A D D E N D U M

ADDENDUM TO REPORT OF DUNCAN MITCHELL, DIRECTOR ENGINEERING & PROPERTY SERVICES DATED 23 MARCH 2020

SUBJECT: Item 19 - North Sydney Olympic Pool Development Application Amendments Requested by the Independent Planner - Heritage Planners and Public Consultation Feedback

DATE: 3 April 2020

Aerial view of the Proposed Design amendments as seen from above Luna Park

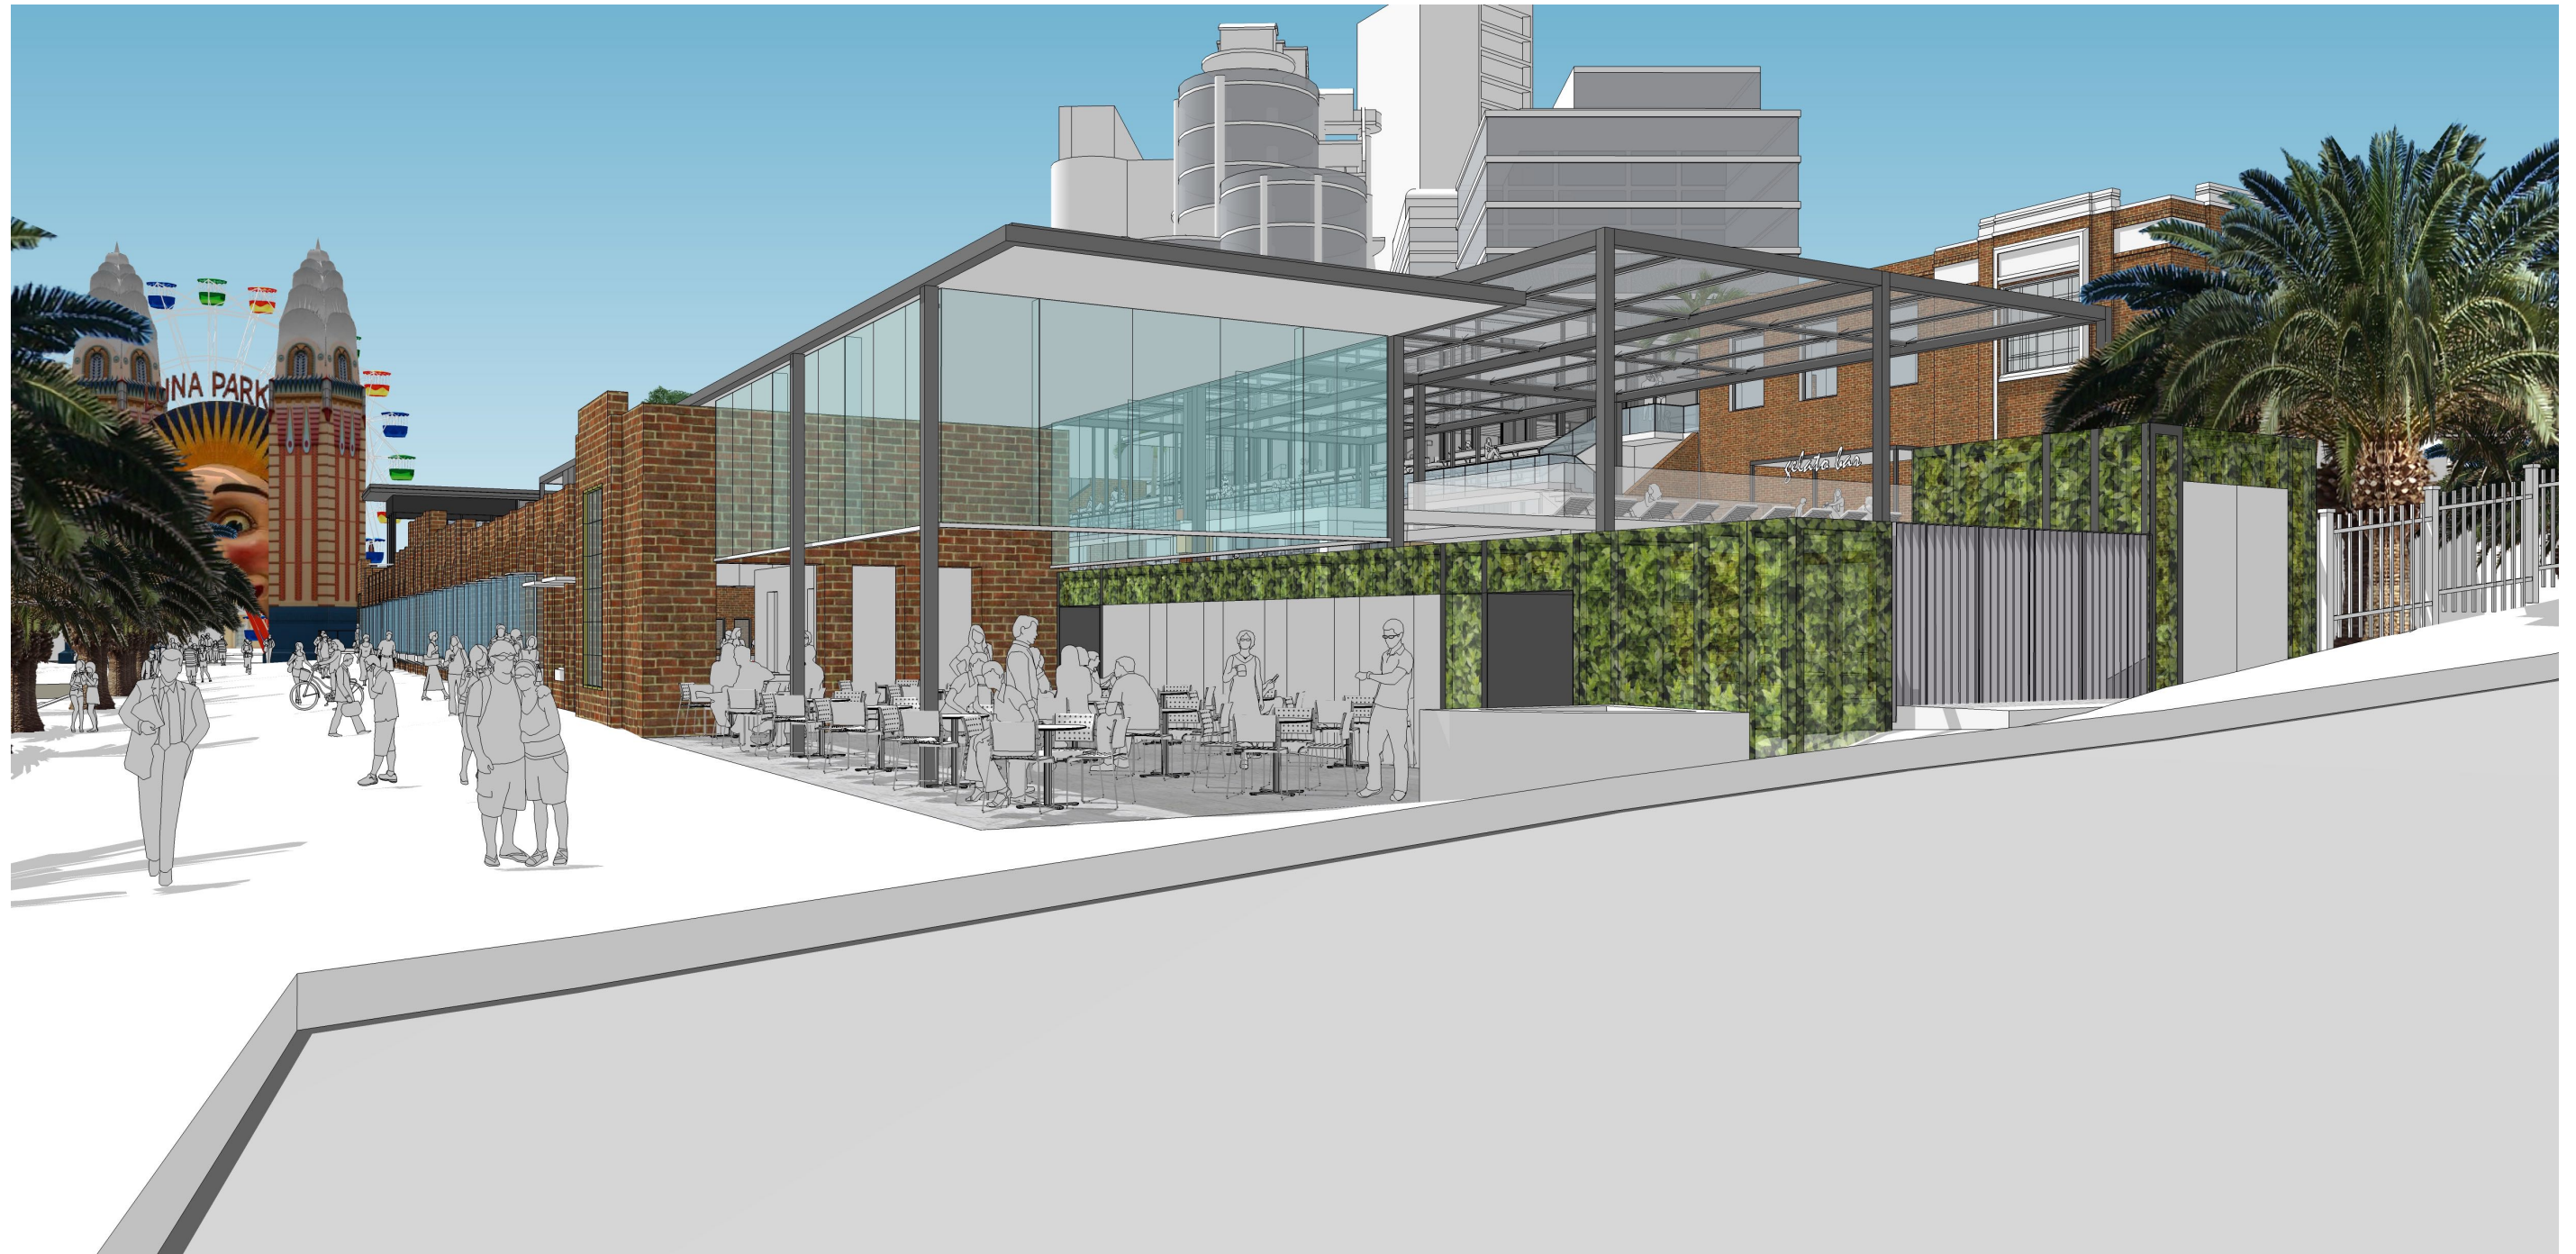
1
the Heritage Assessor feels that the roof of New Ripples Cafe and outdoor dining area is too dominant to the heritage brickwork which forms the corner of the heritage perimeter wall

3
the Heritage Assessor feels that the proposed shade structure is too visually dominant to the sundeck, it should be lowered, or visually reduced in some way

It was agreed in the meeting that BHA would lower the roof below the existing brickwork parapet line

BHA have modified their design to remove the shade structure from the DA application.
